NRL/MR/7441--94-7097

## Digital Mapping, Charting, and Geodesy Analysis Program Technical Review: Digital Nautical Chart Product 1

December 9, 1994

Fig. 1 — Compass rose from DNC chart 12245

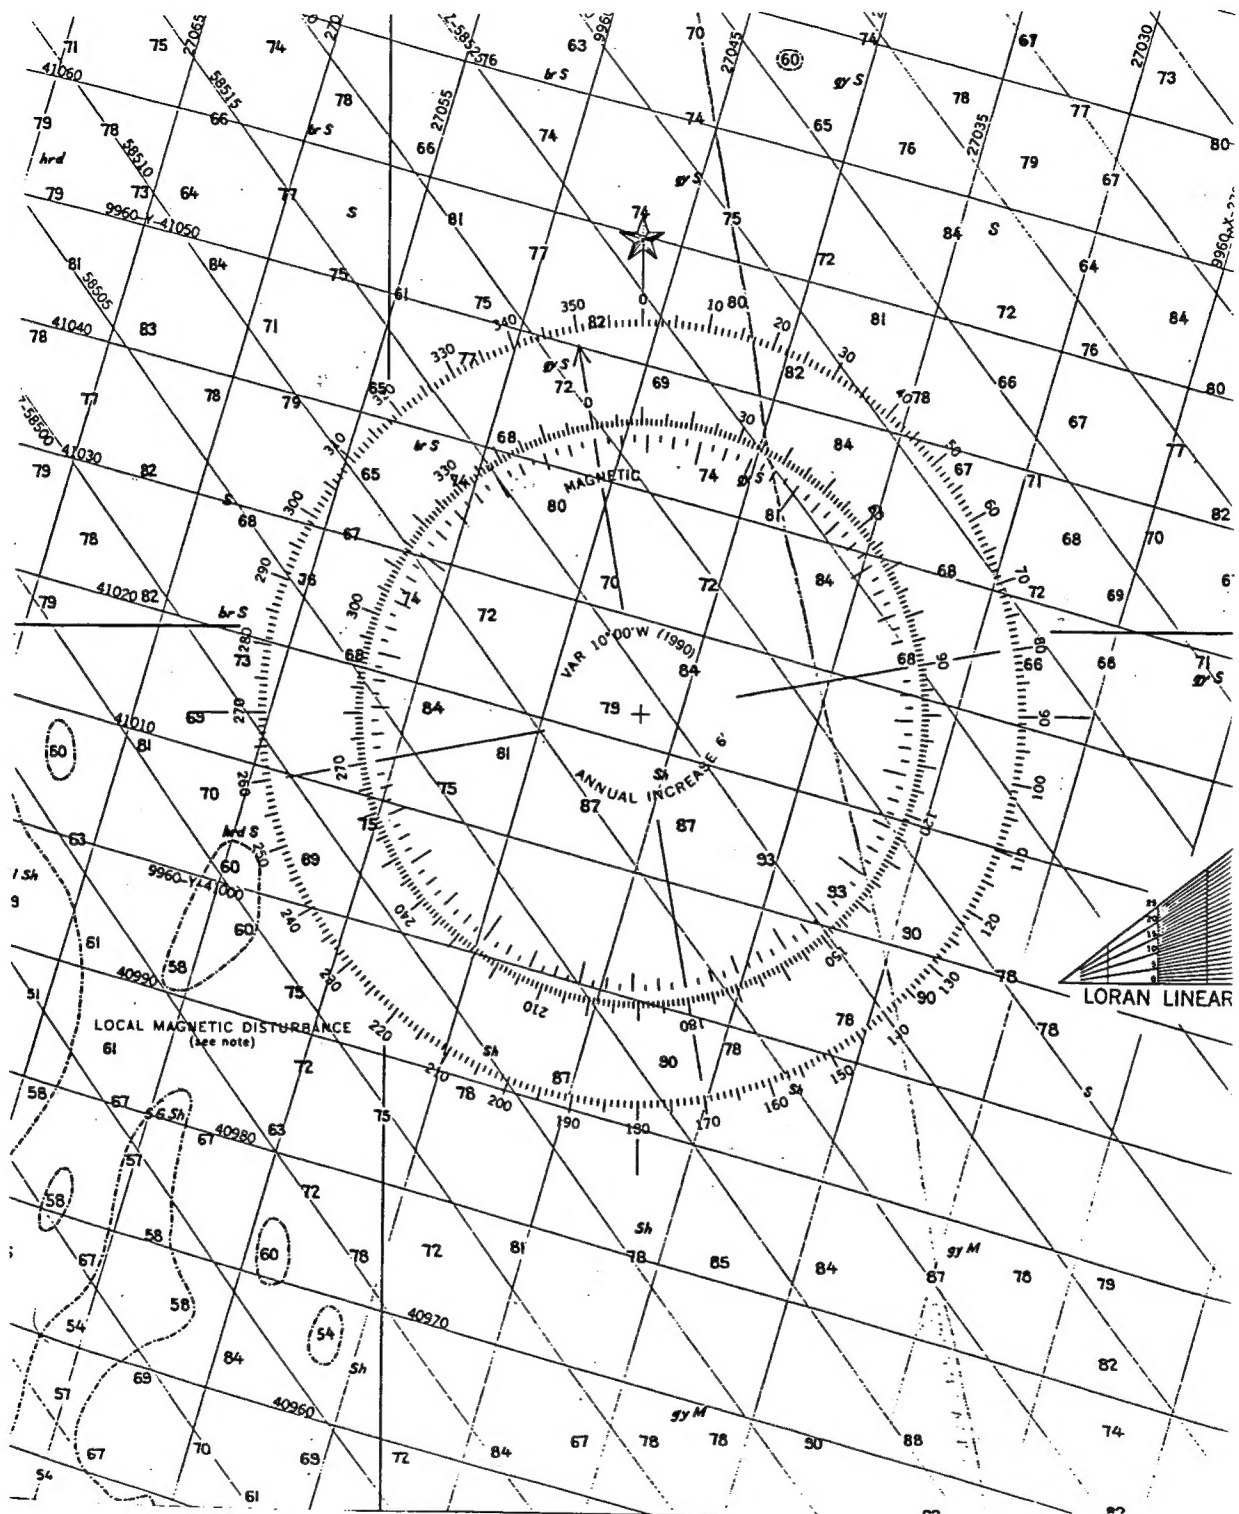
Compass roses (Fig. 1) are used to give information on magnetic variation for the areas in which they are placed. They tell the measure and direction of the variation, the year in which this measurement was made, and the expected annual increase in the variation. This data could easily be represented in the DNC with the creation of a new point feature (i.e., "Magnetic Variation") with three attributes containing the data mentioned above.

Fig. 2 — Magnetic variation lines from DNC chart 12200

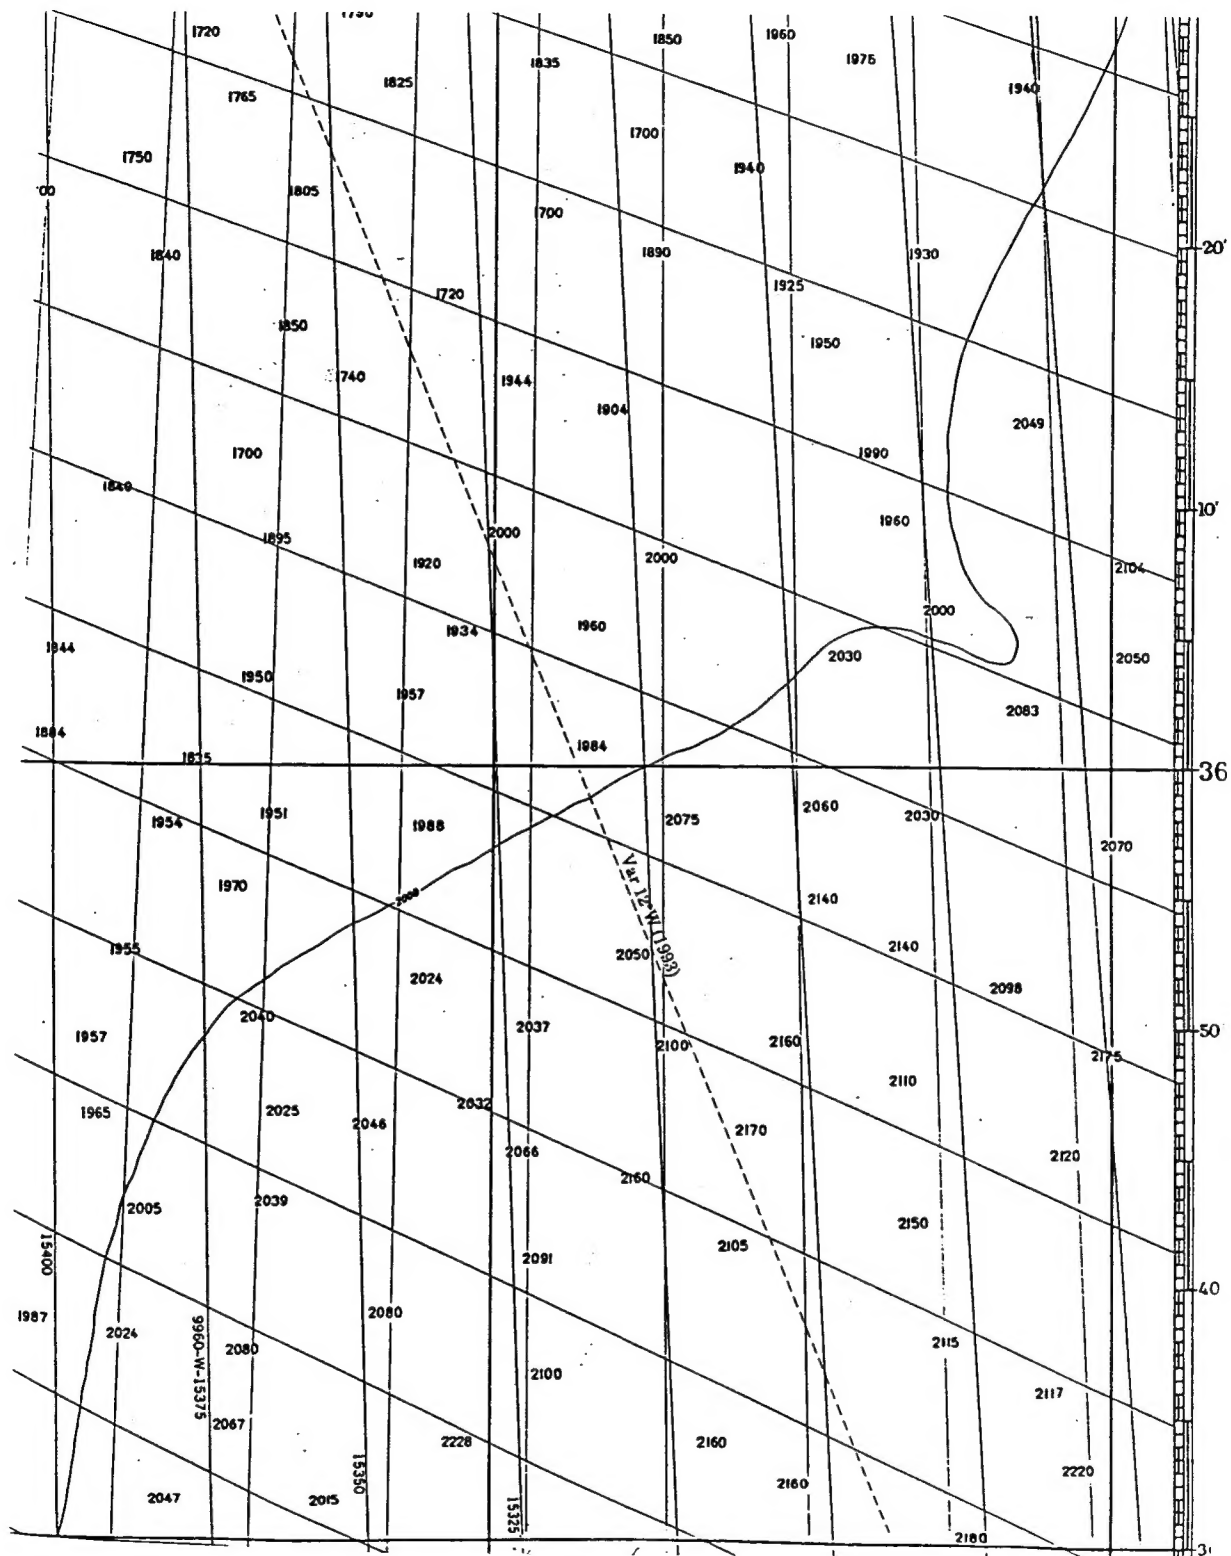
Related to the compass roses, there are also on chart 12200 lines of magnetic variation (Fig. 2). These are lines of constant variation giving the amount and direction of the variation and the year the variation was measured. These could be readily represented as line features.

Fig. 5 — Labeling of DNC features

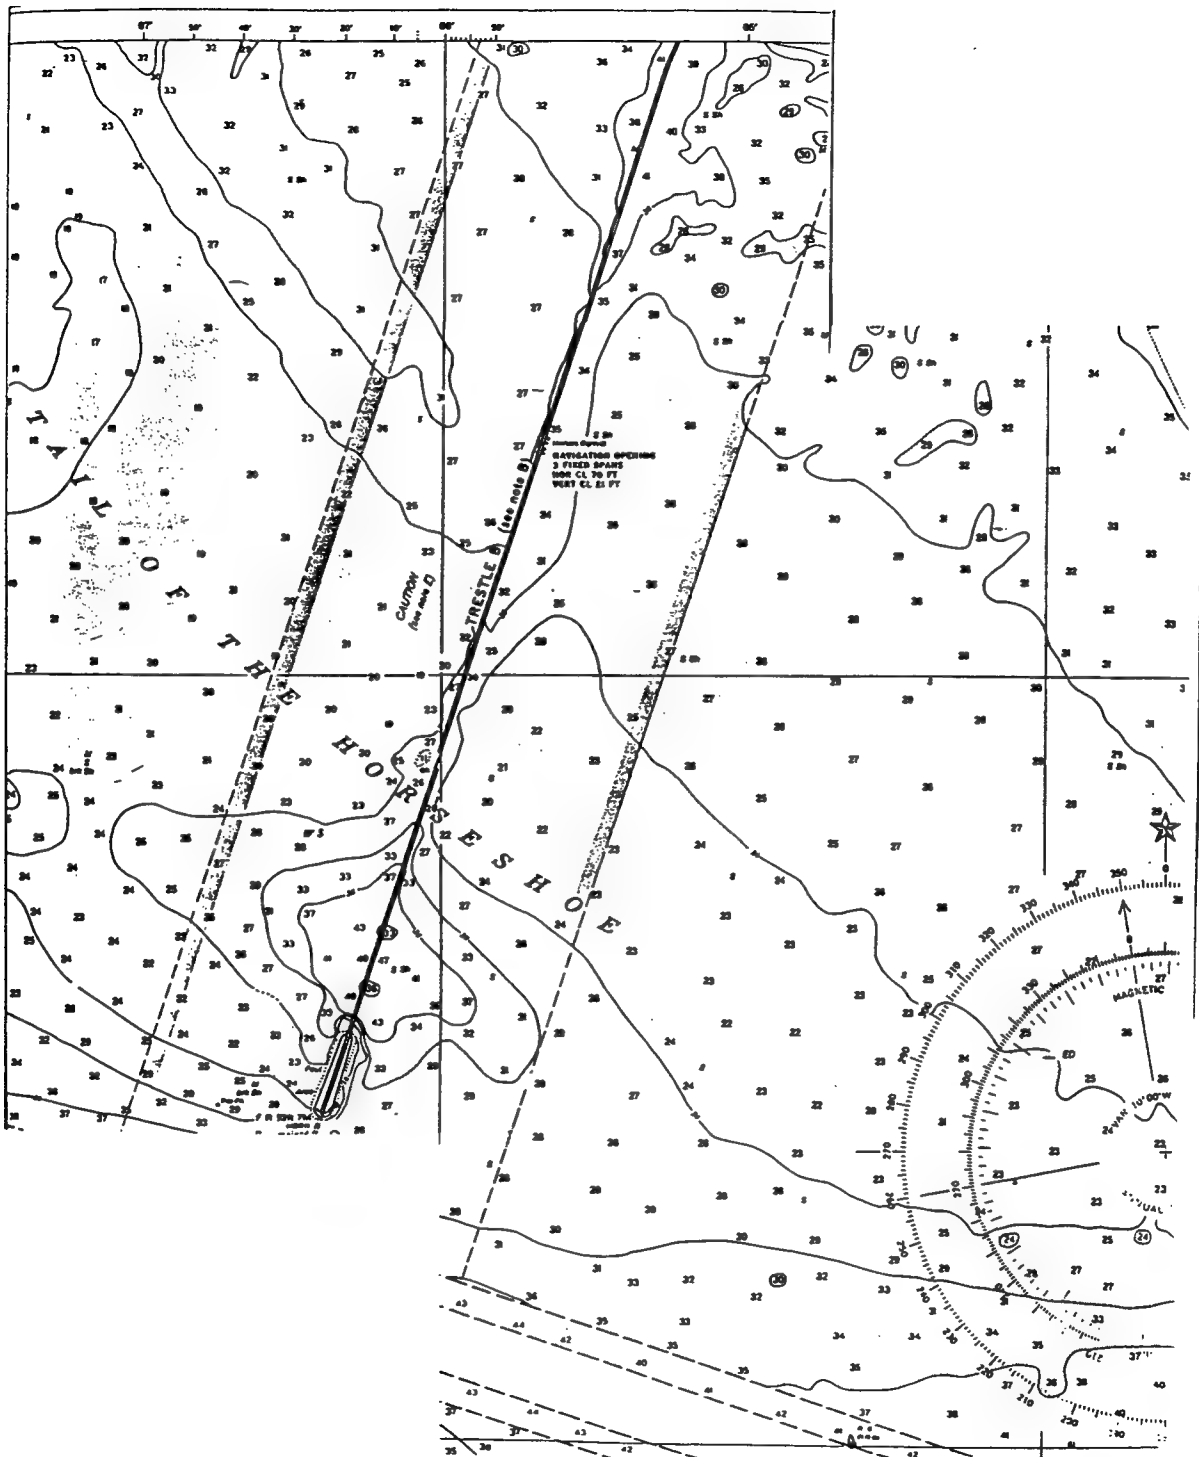
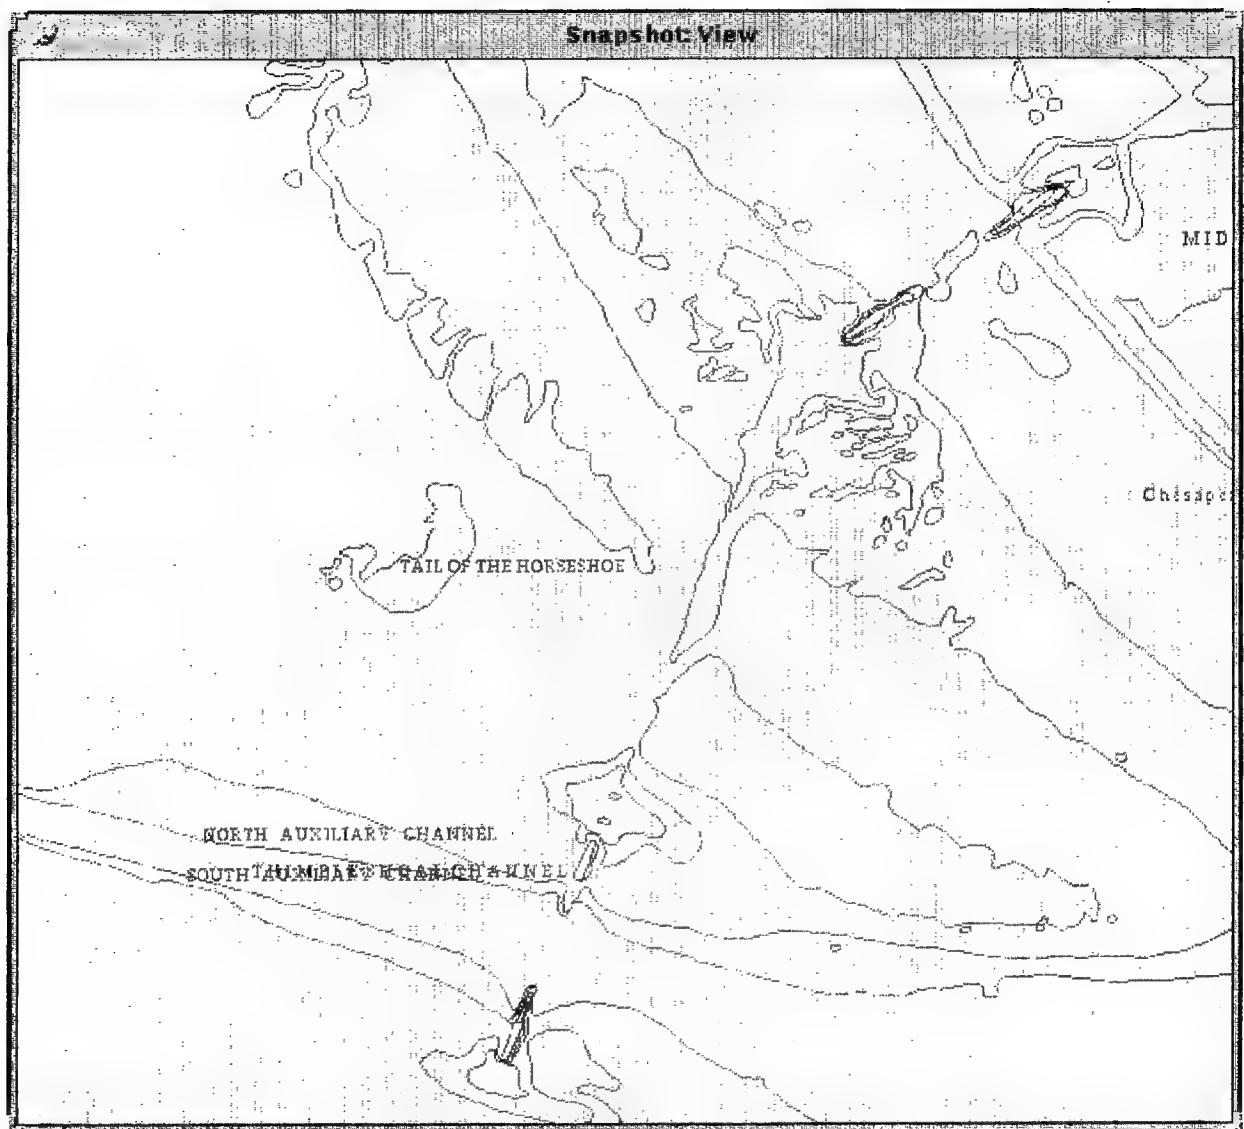
As mentioned in previous DMAP reviews of the DNC, text would be more descriptive if it followed the feature that it describes. Figures 4 and 5 represent labeling on the original paper chart

and in the DNC, respectively. As can be seen by comparing the two figures, the label in Fig. 4 follows the feature, but in Fig. 5 the label is almost perpendicular to the feature. This could cause obvious confusion.

Fig. 6 — Interchart inconsistencies due to different DNC chart scales in the Harbor library

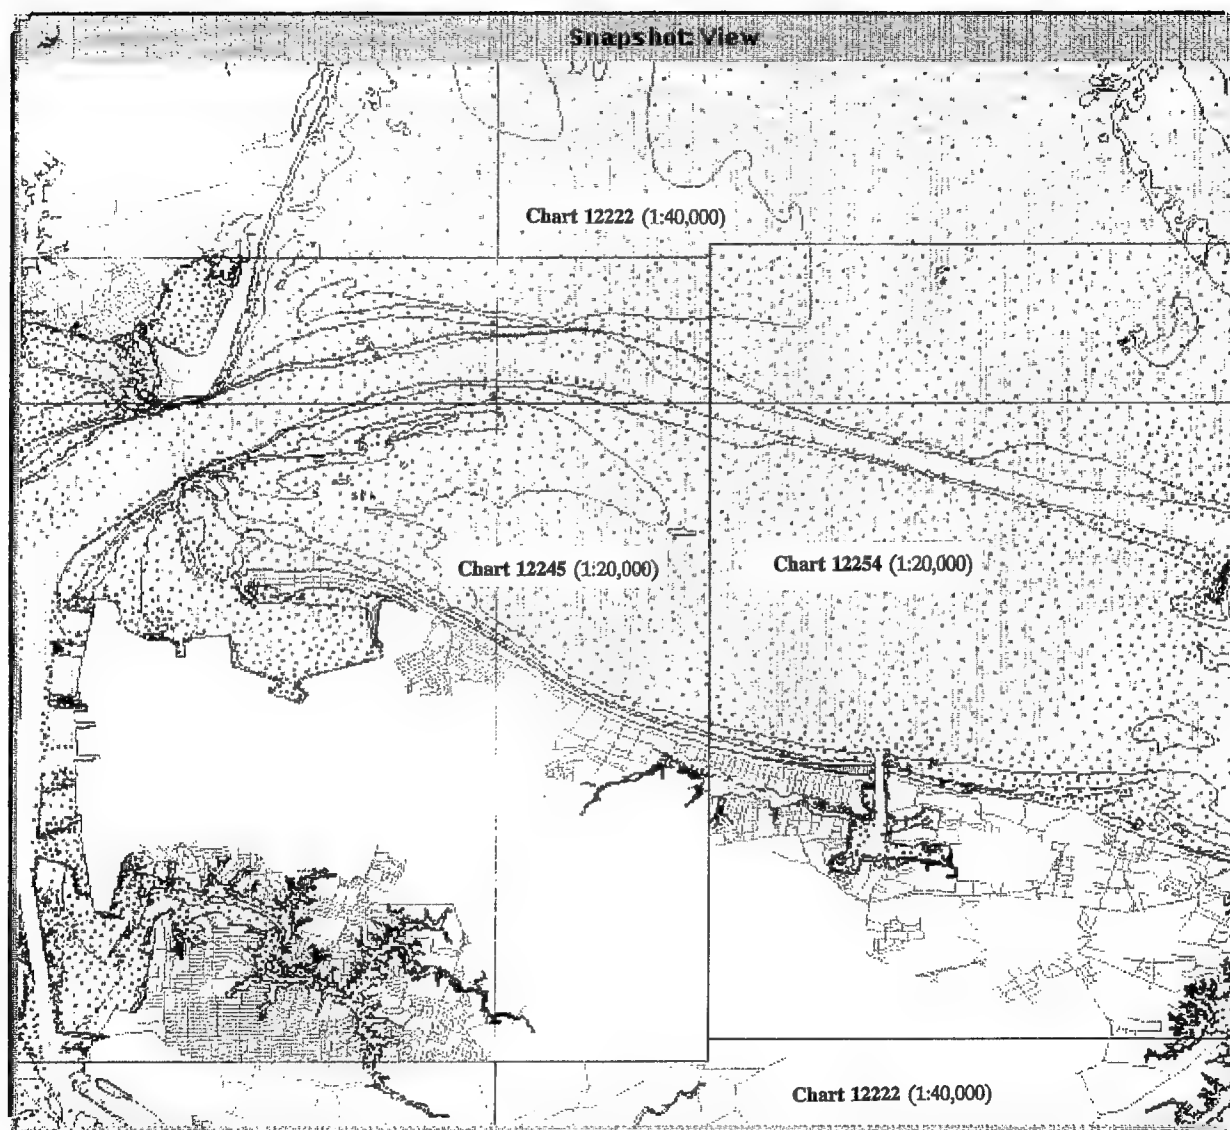
In several instances, where charts of different scales in the same library meet, an unexplained change in the data occurs. This change is especially true in the Harbor library since the library consists of three different charts with two different scales. As an example, Built-up Areas on chart 12222 (1:40,000) abruptly ends where chart 12245 (1:20,000) begins (Fig. 6). Chart 12245 has no Built-up Areas, but instead shows a dense network of streets. A similar situation occurs in Fig. 6 with Soundings in the Hydrography layer. There is a noticeable line across Chesapeake Bay where the low density of soundings on chart 12222 suddenly ends and the higher sounding density on charts 12245 and 12254 begins (both 1:20,000).

Fig. 7 — Depth contour areas in DNC Harbor library

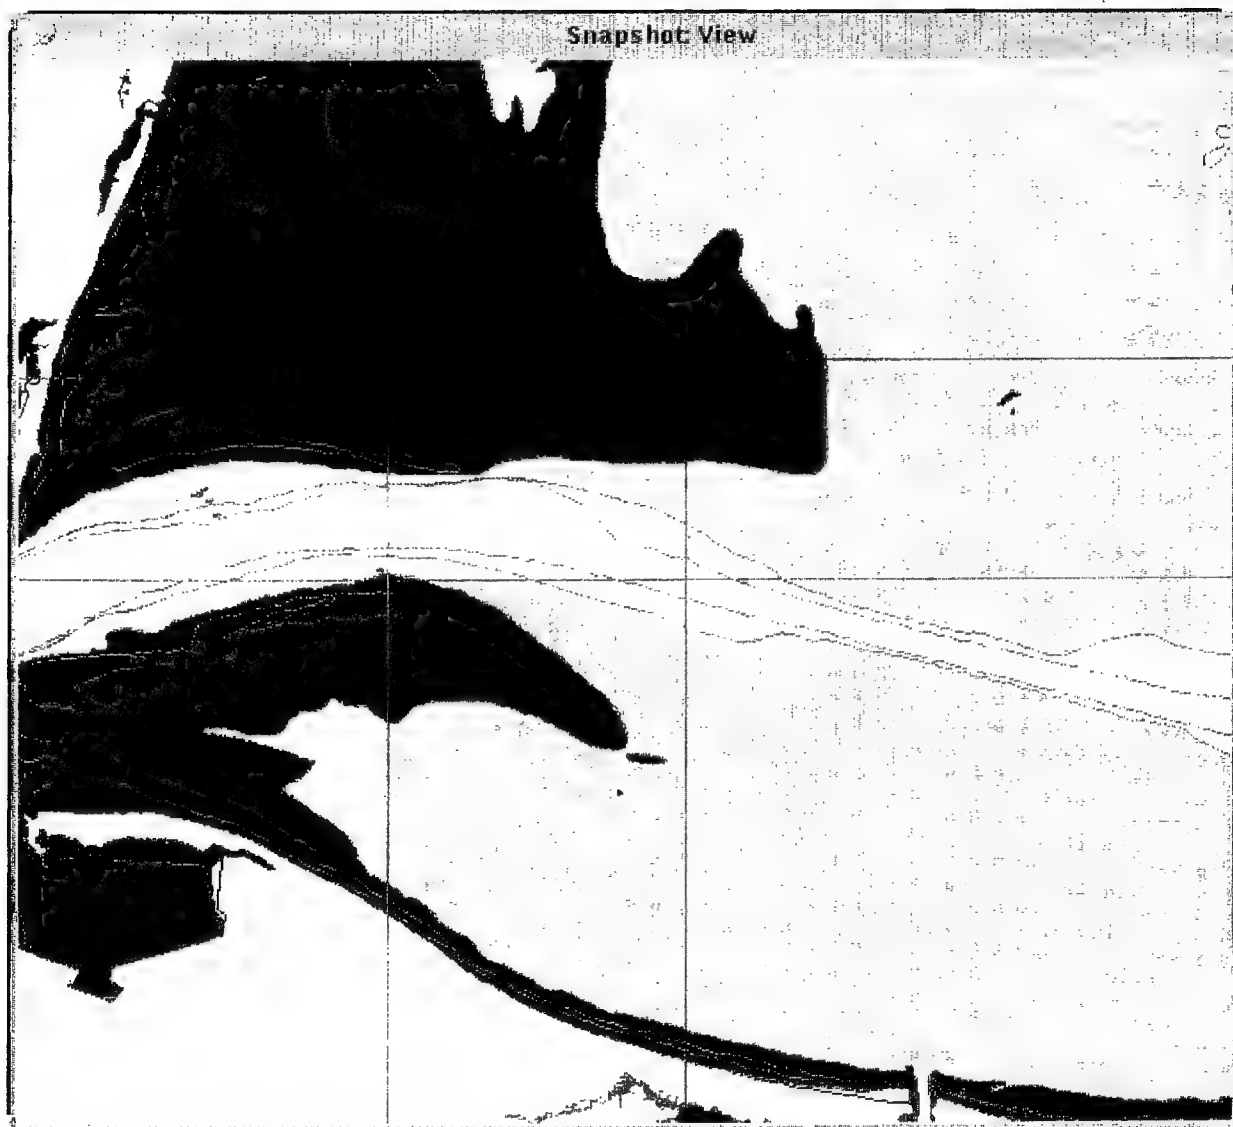
A more significant problem is where the Depth Curve areas of DNC Tiles 5 and 6 meet south of Willoughby Bank. Here a small portion of a larger Depth Curve area is contained on Tile 5 with the rest of the area on Tile 6 (Fig. 7). Both portions are entered into the DNC database with different Contour Value High attributes, causing them to graphically appear as two separate Depth Curve areas instead of one.
